UNITED STATES
NUCLEAR REGULATORY COMMISSION
WASHINGTON, D. C. 20555

SUPPLEMENTAL SAFETY EVALUATION BY THE
OFFICE OF NUCLEAR REACTOR REGULATION
ROCHESTER GAS AND ELECTRIC CORPORATION
R. E. GINNA NUCLEAR POWER PLANT
GENERIC LETTER 83-28, ITEM 4.3
REACTOR TRIP BREAKER AUTOMATIC SHUNT TRIP

Simplified Schematic Diagram
 Illustrating Independent Testing of
 Reactor Trip Breaker UV and STA Devices and
 Logic Relay Contracts

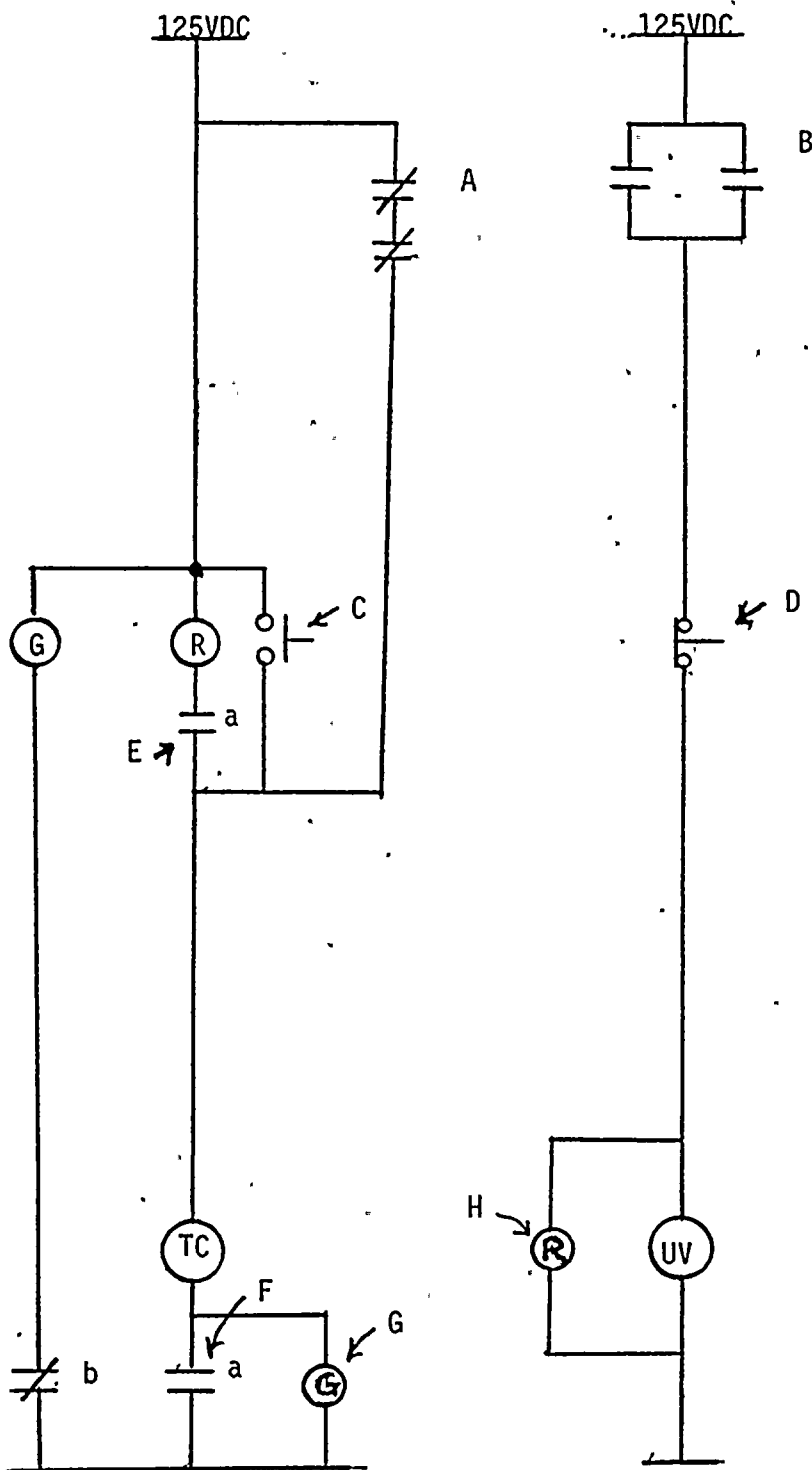
The Ginna design for the shunt trip actuation of the reactor trip breakers differs from the generic design provided by the Westinghouse Owners Group in that the Ginna design does not use an auxiliary relay to initiate the shunt trip actuation. Instead, the spare contacts of the existing reactor protection

system logic relays arranged in a matrix are used for automatic actuation of the shunt trip device. Attachment 1 is a simplified schematic diagram to conceptually illustrate the design. The letters in parenthesis used below refer to those on the attachment.

The logic relay contacts (A) and (B) operate simultaneously to trip the RTB. The (A) contacts close to energize the shunt trip attachment TC and the (B) contacts open to deenergize the UV coil. The red light (H) across the UV coil goes off and the green light (G) across the RTB's "a" contact (F) goes on to indicate successful operation of the relay contacts (B) and (A), respectively. This test checks the operation of the relay contacts and does not independently test the UV coil and STA of the RTB. The test can be made with the RTB in the test or racked-in position and in the tripped condition.

Independent testing of the UV trip device and STA of the reactor trip breakers is accomplished using manual test pushbuttons or switches. For the shunt trip test, a test pushbutton (C) in parallel with the spare contacts (A) of the automatic trip logic matrix can be used for manual independent on-line testing of the STA. The UV trip circuitry is not actuated by this test. We find this independent on-line testing capability acceptable.

For the UV trip test, operation of the center plunger on a relay in the zirconium guide tube circuitry can be used to interrupt power flow to the UV coil without actuating the STA as follows. A unique feature of the Ginna station is the zirconium guide tube interlock circuitry. This circuitry is not required for the reactor protection but assures that the control rods are not engaged in the grippers during plant cooldown when different materials may experience different thermal contraction rates. The zirconium guide tube circuitry provides additional relay contacts (D) in series with the protection system logic relay matrix for the UV trip. These contacts can be opened by operating the center plunger of the relay. Opening of these relay contacts tests the operability of the UV trip coil by interrupting the power flow to the UV trip coil without affecting the STA circuitry. We find this on-line testing capability acceptable.
